No. EL/3.2.61/Gen.

Dt. 13.02.2014

**MODIFICATION SHEET NO. RDSO/2006/EL/ MS/0345 (REV. '1'),
Dated 13.02.2014**

Standardisation of earthing switch arrangement on 3-phase locomotives to make interchangeable of various makes of VCBs between single and 3-phase locomotives.

- 4.1 VCB & Earthing switch locations will remain same at their original locations of the 3-ph locomotives. The arrangement is shown in drawing No. SKEL-4704.

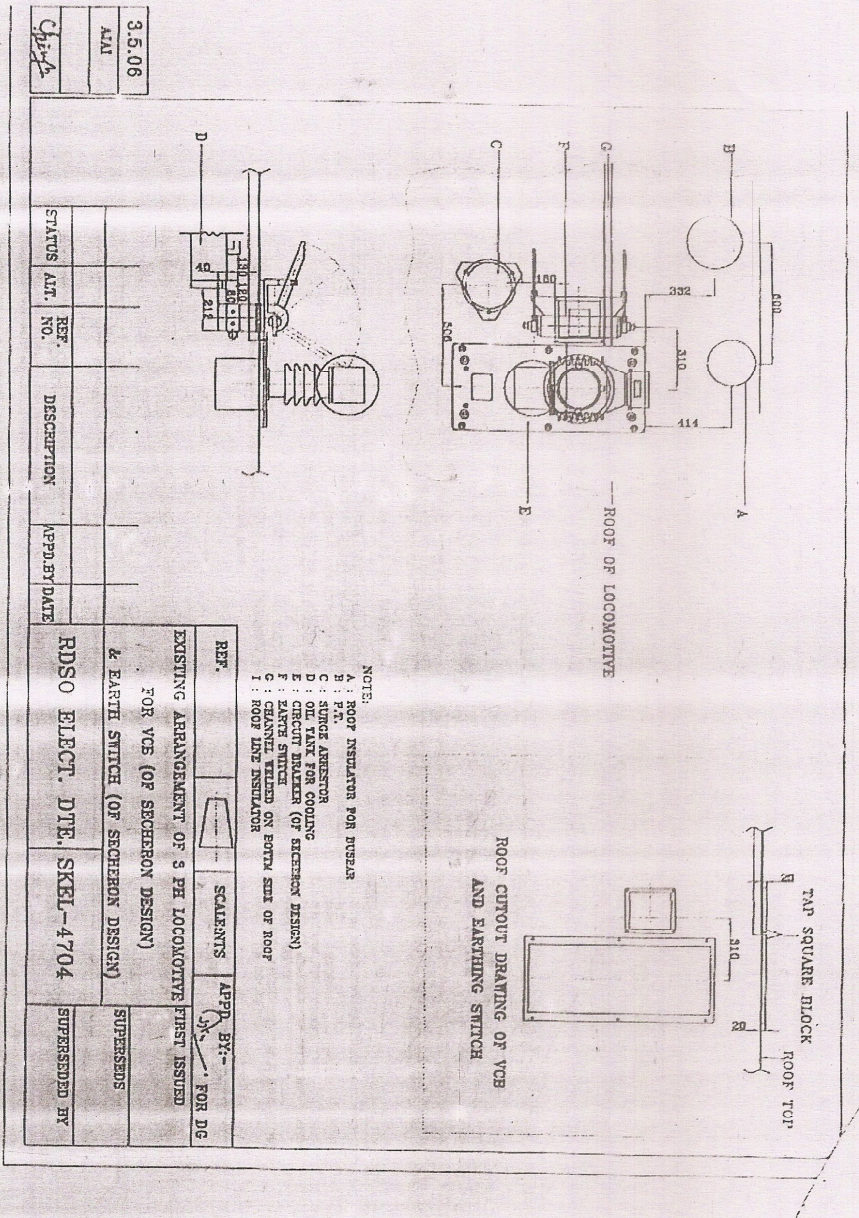
- 3.1 Existing arrangement of 3-phase locomotives for Secheron design circuit breaker and earthing switch is shown in enclosed drg, no.SKEL-4704. In this arrangement the moving blades of earthing switch are engaged with contact clips directly attached with the horizontal insulator of VCB.
- 3.2 Modification of earthing switch arrangement on 3-phase locomotives as per the Rev(0) of this modification is shown in drawing No. SKEL-4706. In this modification, the existing HOM was shifted by 205 mm (as per drg. No.SKEL-4706) with increased mounting collar height by 70 mm from loco roof. Additional 02 nos. roof insulators were required with attached contact clips arrangement to receive moving blades of HOM.

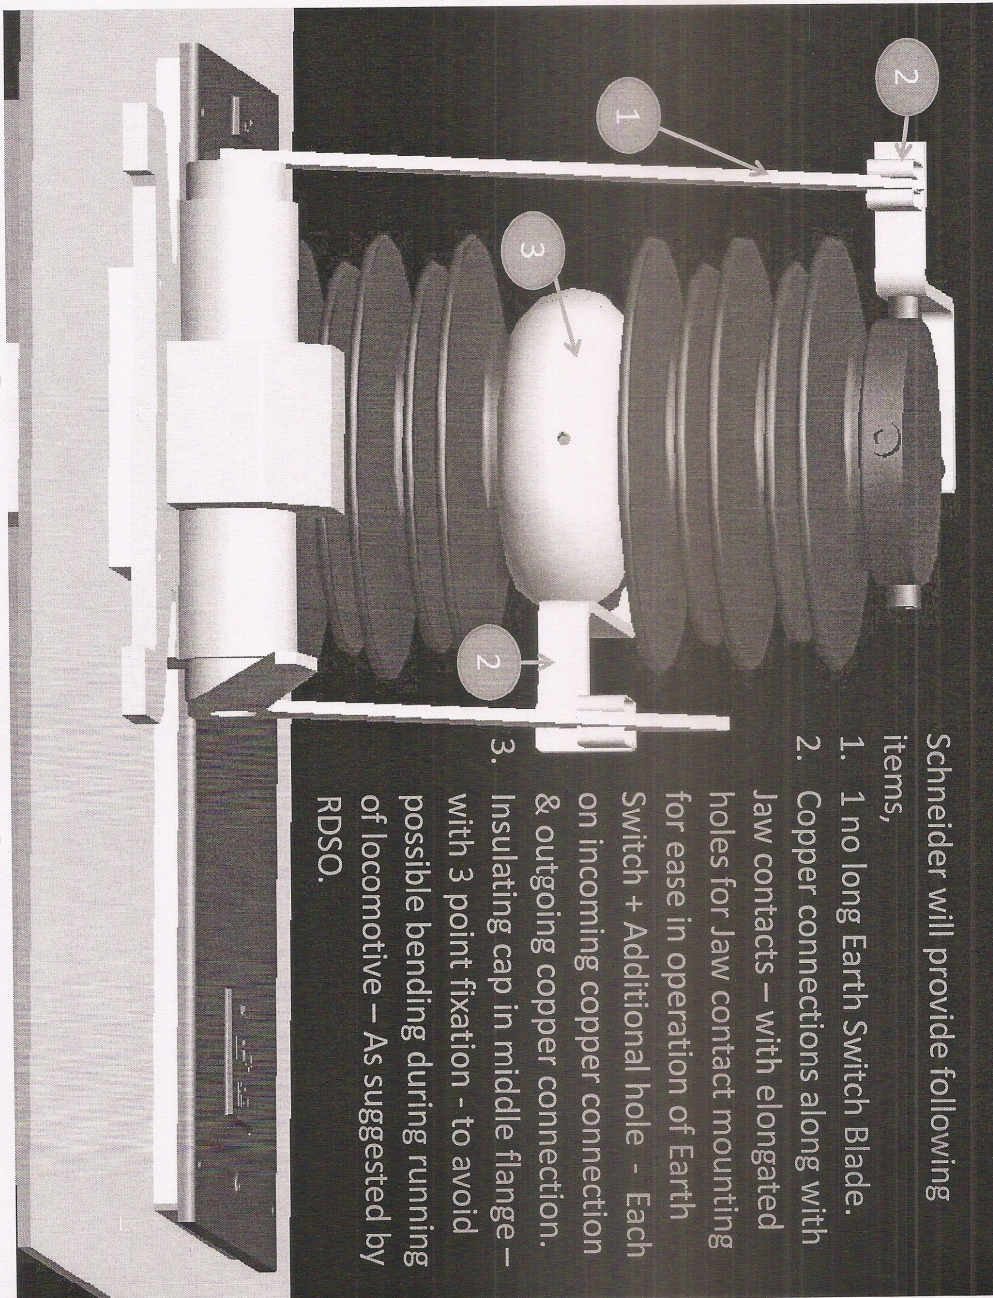
- 4.3 Replacement of one arm of the earthing blade of the existing earthing switch with longer arm of the earthing blade in one piece for the earthing switch as per sketch at Annexure-I is to be done by the Railways for fitment of Schneider make VCBs.

- 4.5 Copper connections along with jaw contacts have provision of enlarged holes for mounting finger contact for better alignment of earthing contacts has been provided(Annexure-I, Point 2). Additional holes have also been provided in the incoming & outgoing copper connections for flexibility in connections.

CUSTOMER :		DATE :	
CONSULTANT :		P.O. NO. :	
DRAWING MODIFIED AS PER RDSO REQUIREMENT		FLANGE CAP FOR 3 PH ARRANGEMENT	
REV/NO	DESCRIPTION	SCALE	TITLE :
A	SEIL	1:1	DRAWN : RISHI 09/07/13 CHECKED : RISHI 09/07/13 VKG 09/07/13
		DRAWING NO.	SHEET NO. REV.
		LSC:842	00 A

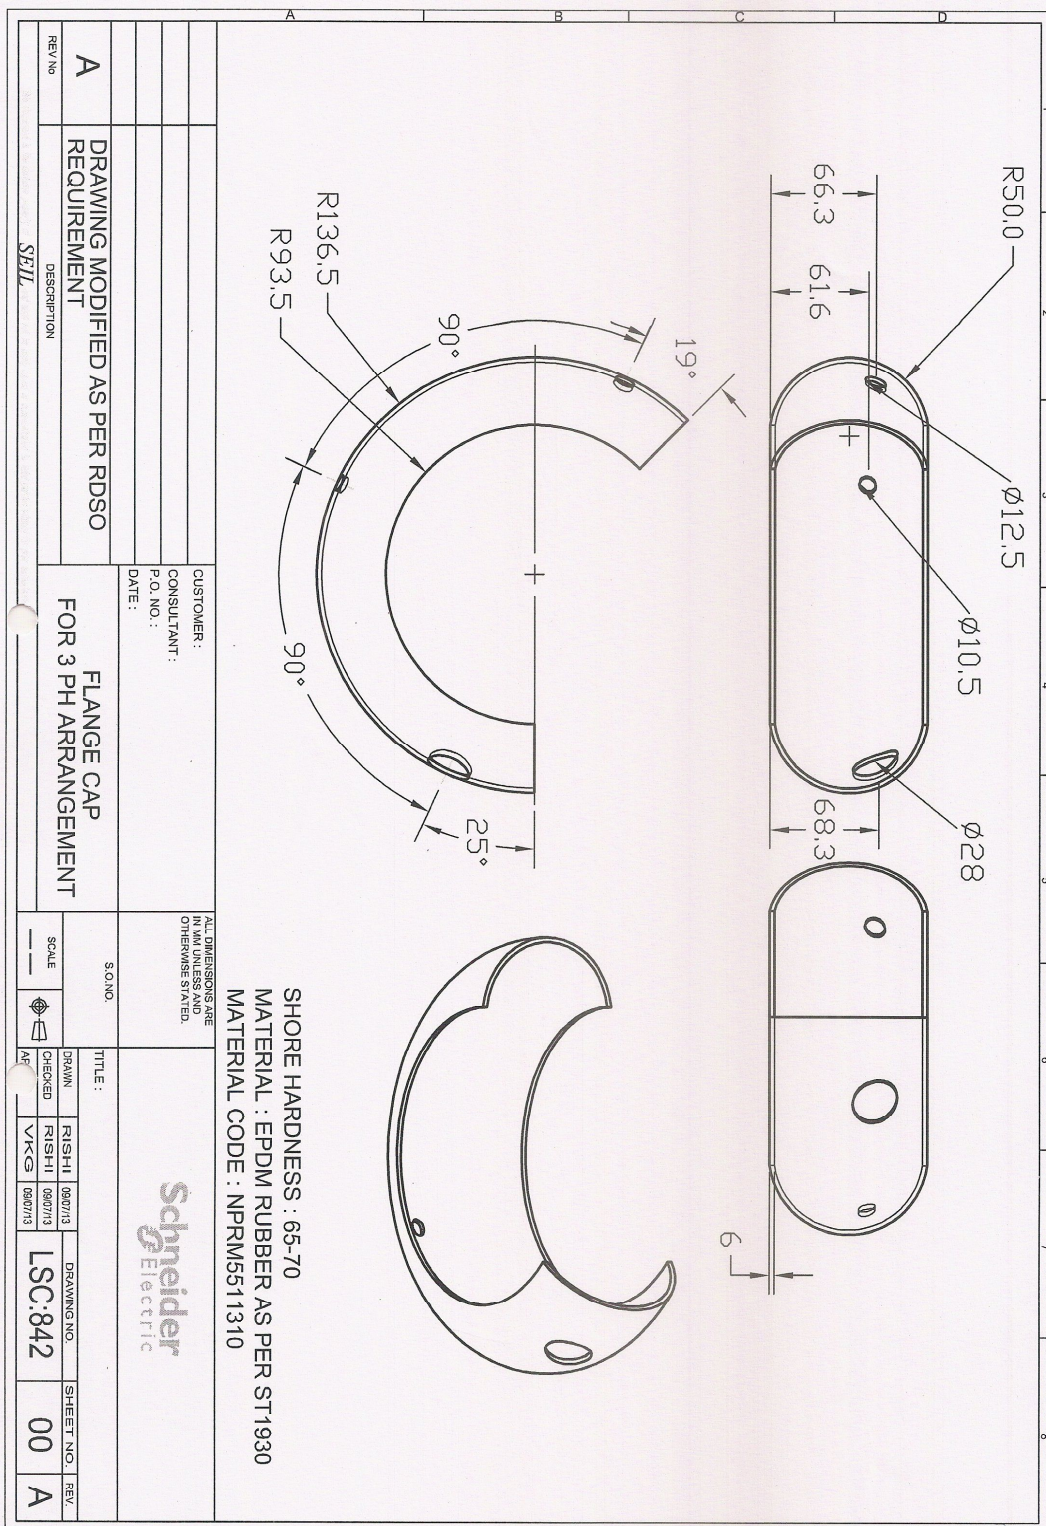
- 4.2 Provision has been made for insulating cap at lower terminal of the Schneider make VCBs type 22CB as per their drawing No.LSC:842, rev. 'A' to cater 250 mm earth clearance.

SHORE HARDNESS : 65-70
 MATERIAL : EPDM RUBBER AS PER ST1930
 MATERIAL CODE : NPRM5511310
